14201 Southington Road

For variances to replace the parking lot, relocate and expand the playground, and enclose the dumpsters and generator.

STAFF REPORT

LUDLOW SCHOOL - site design analysis

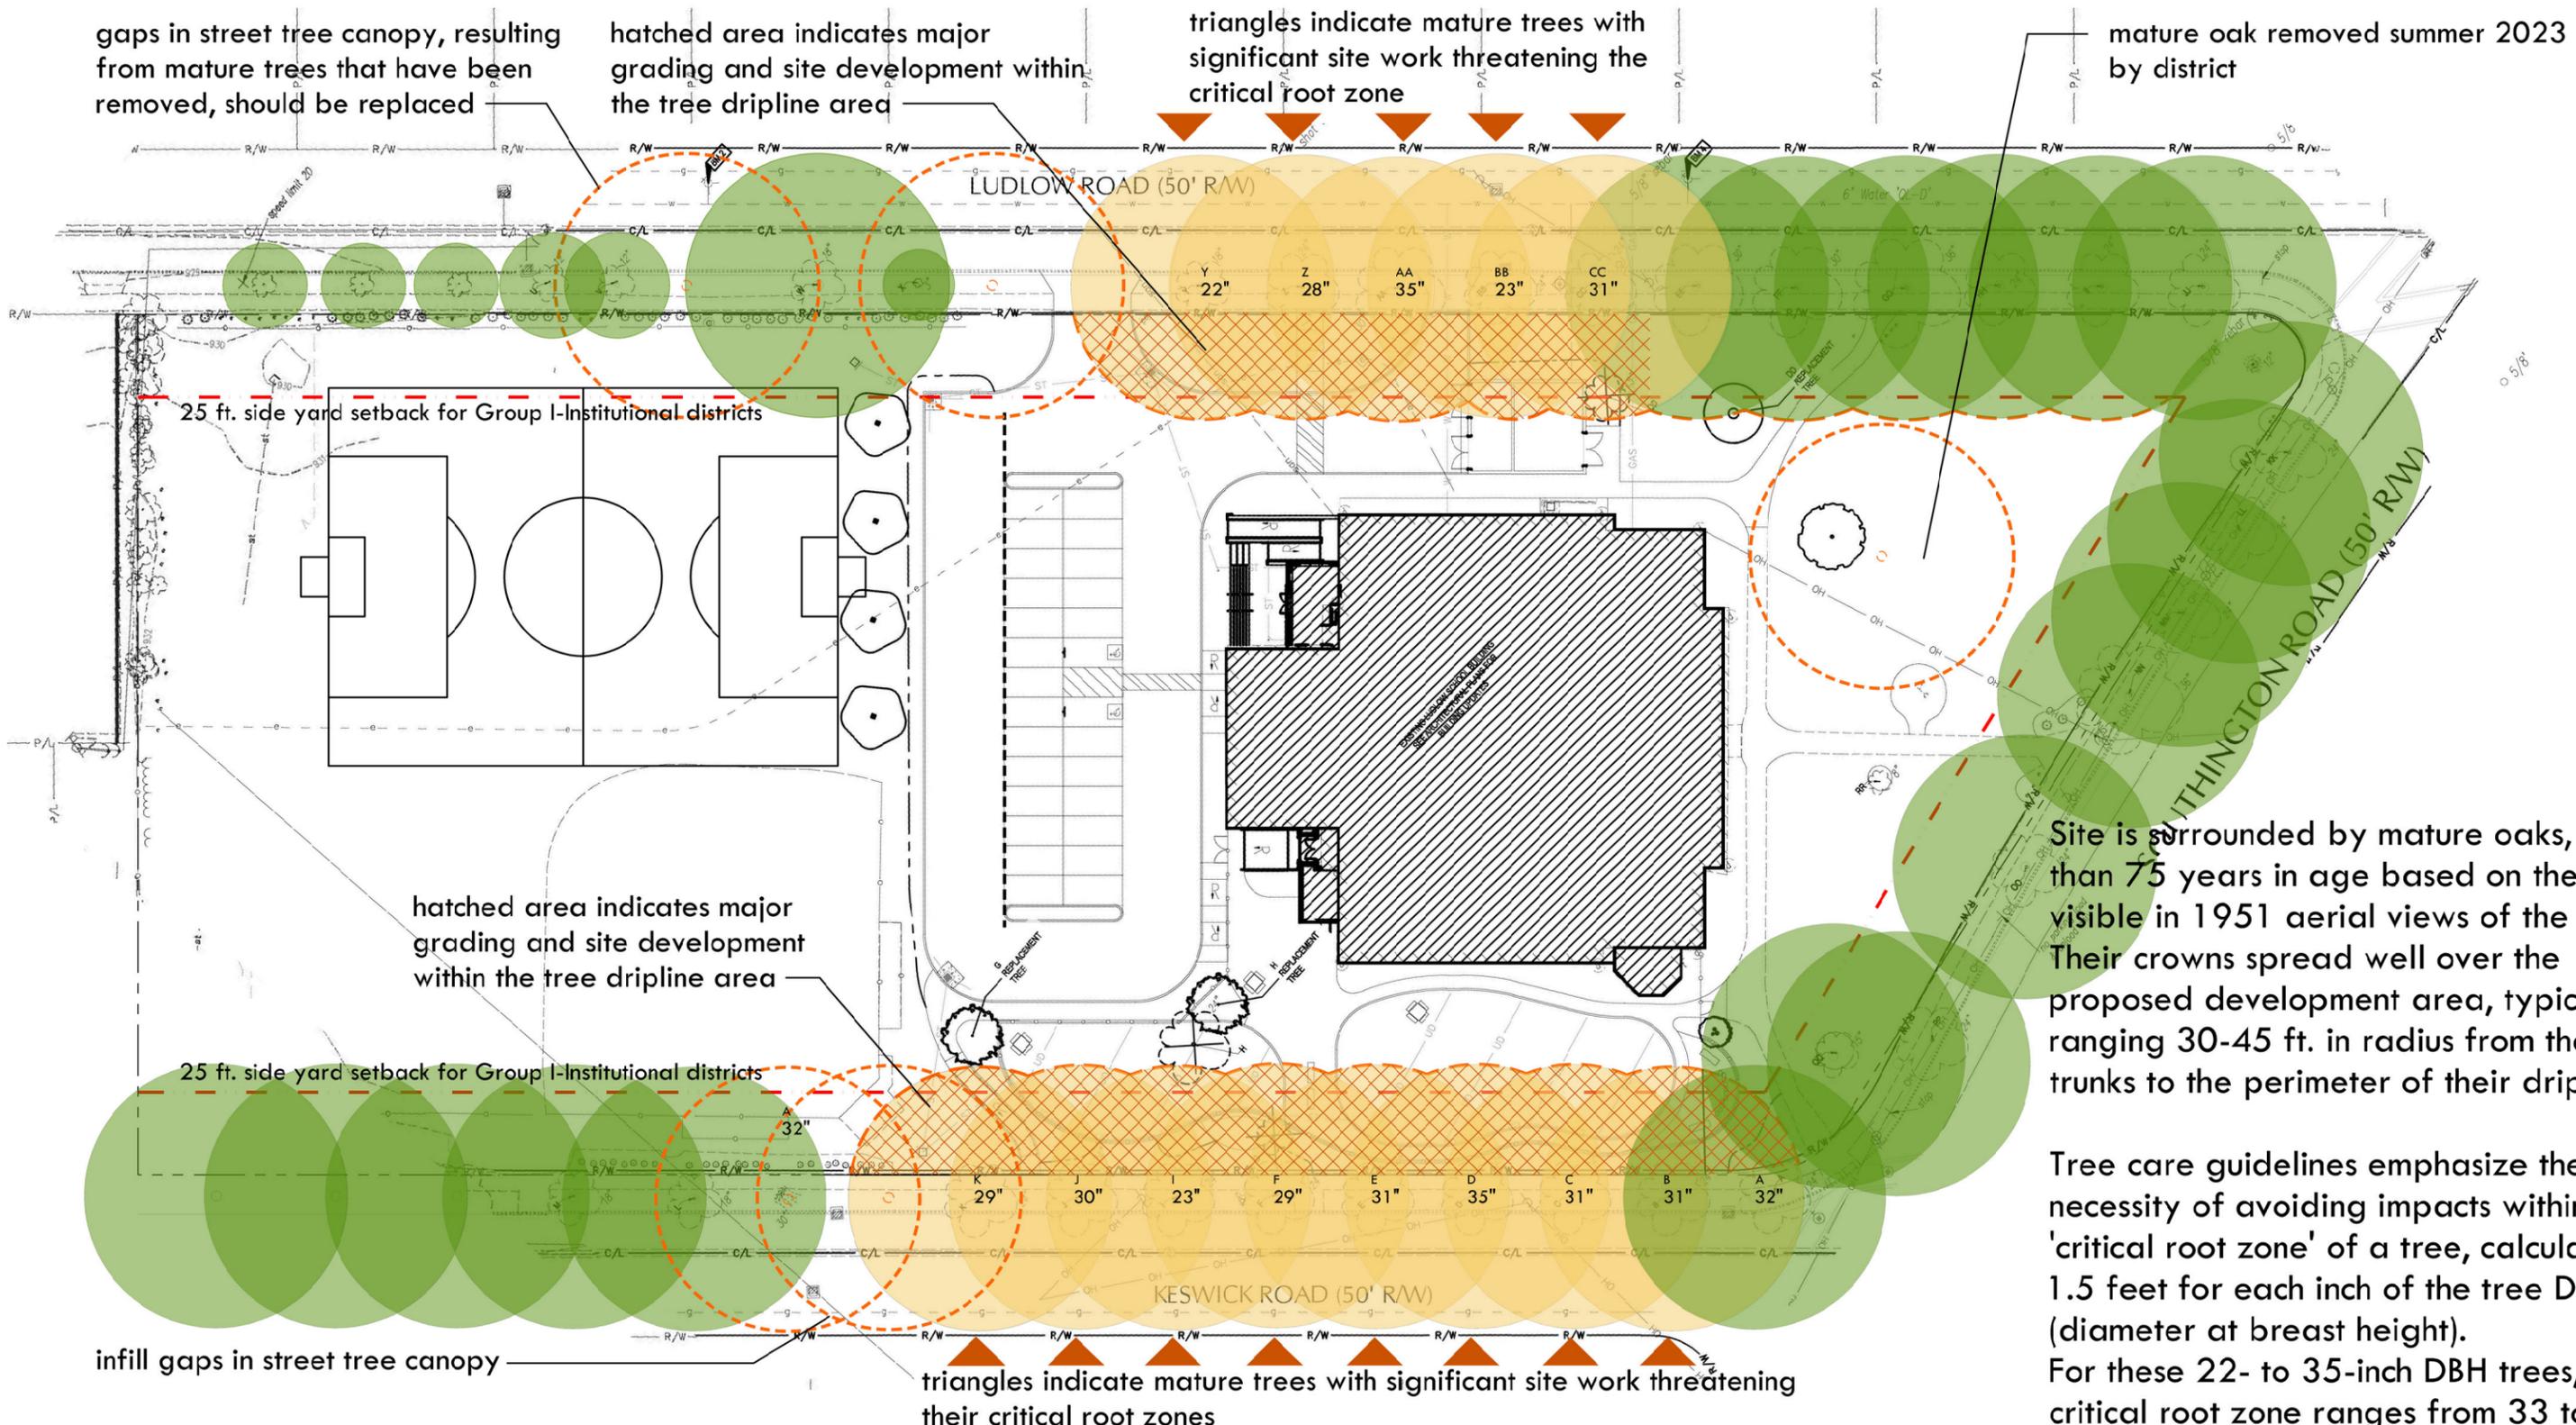
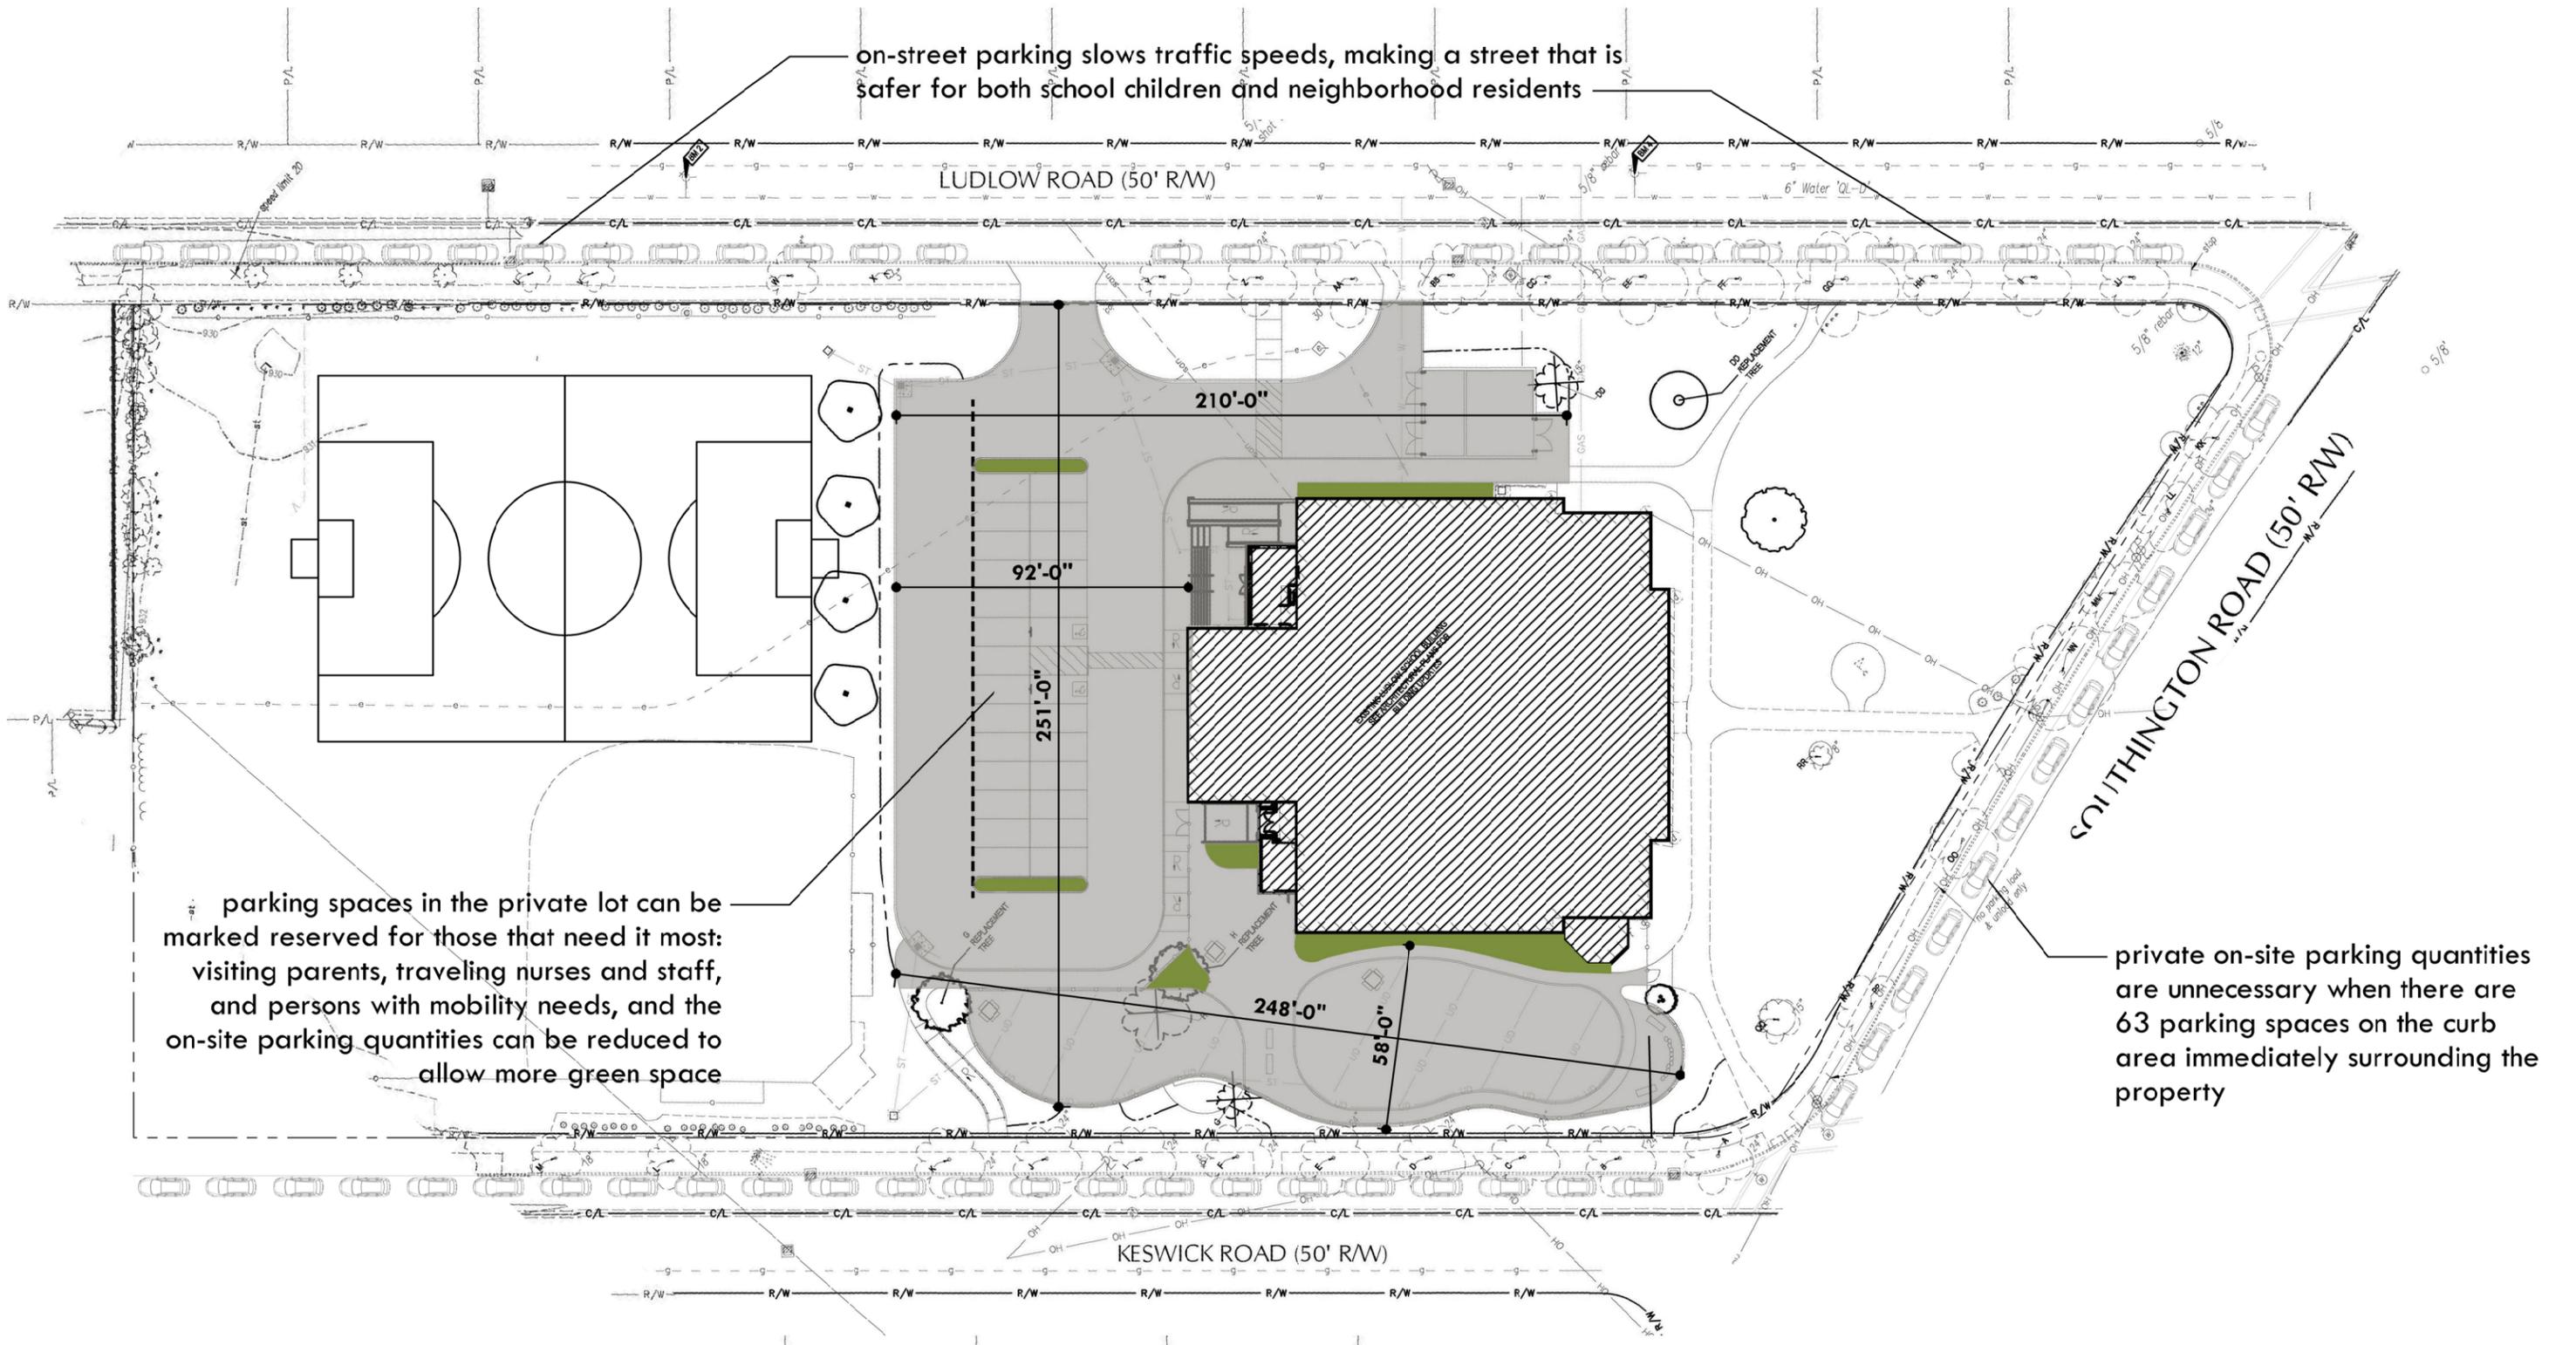
Site is surrounded by mature oaks, more than 75 years in age based on their sizes visible in 1951 aerial views of the site. Their crowns spread well over the proposed development area, typically ranging 30-45 ft. in radius from their trunks to the perimeter of their driplines.

Tree care guidelines emphasize the necessity of avoiding impacts within the 'critical root zone' of a tree, calculated at 1.5 feet for each inch of the tree DBH (diameter at breast height). For these 22- to 35-inch DBH trees, the critical root zone ranges from 33 to 52 feet in radius from the trunk

Consultation with a certified arborist is essential before proceeding with design to avoid threats to tree survival.

**LUDLOW SCHOOL - site design analysis
parking lot tree islands and green space**

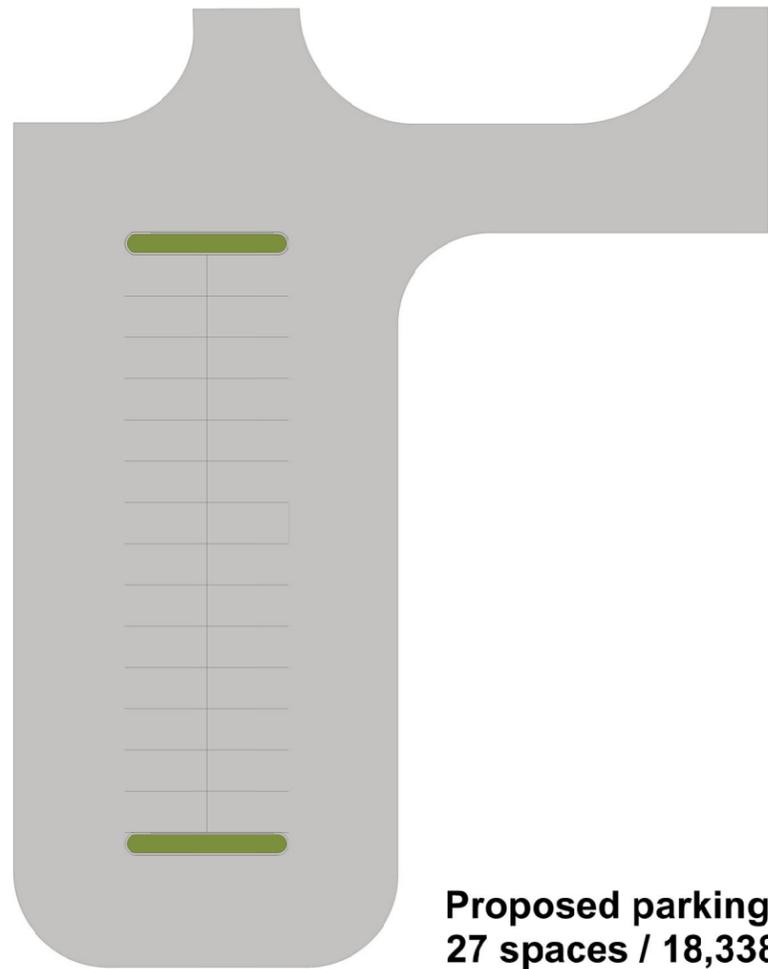
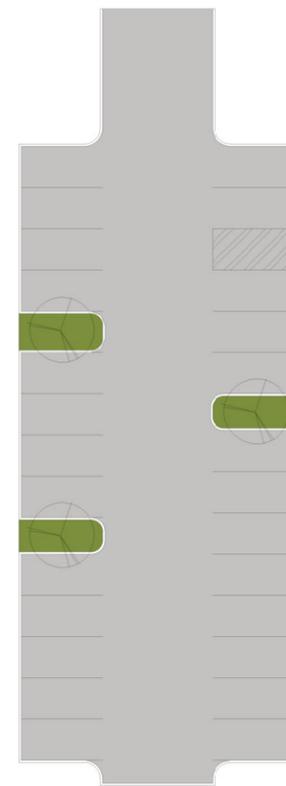
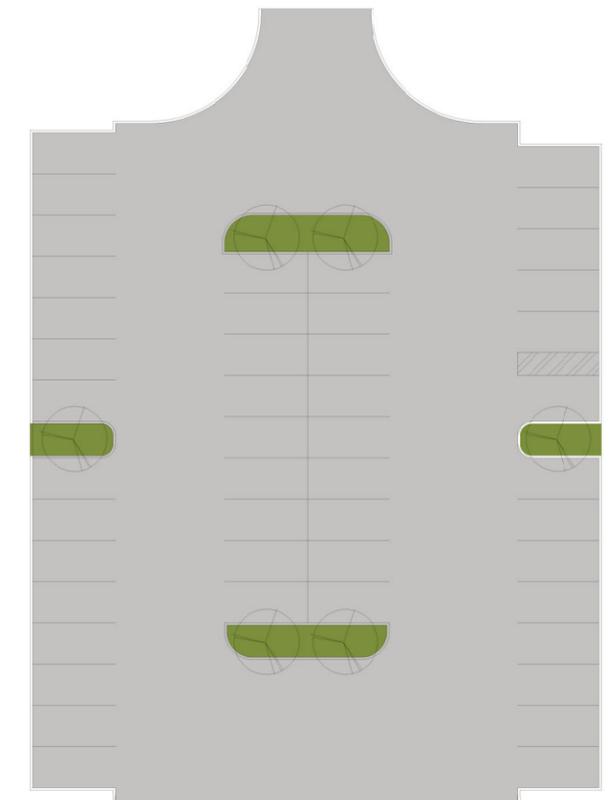
Grey shaded area represents approx. 33,650 sq. ft. of hard / unplanted surfaces: asphalt, sidewalks, trash enclosure, safety surface surrounding the school on three sides, nearly uninterrupted by planting areas or trees save for a few very small pockets that could be planted.

**Proposed parking lot:
27 spaces / 18,338 sf pavement**

$27 / 10 = 2.7 * 120$ sf tree island per 10 spaces
= 324 sf green space required

272 sf green space provided
in area between curb interior edges

This conventional parking lot layout provides the same parking quantity in an asphalt surface that is 47% smaller

This conventional lot layout of identical surface area to the proposed design requires 178% more tree island area than the proposed design

However, section 1213.06-E-3-d in describing the CPC's standards for site plan review notes the specific charge to "Break up large expanses of asphalt with plant material", and certainly additional interior parking lot landscaping is necessary to do so here.
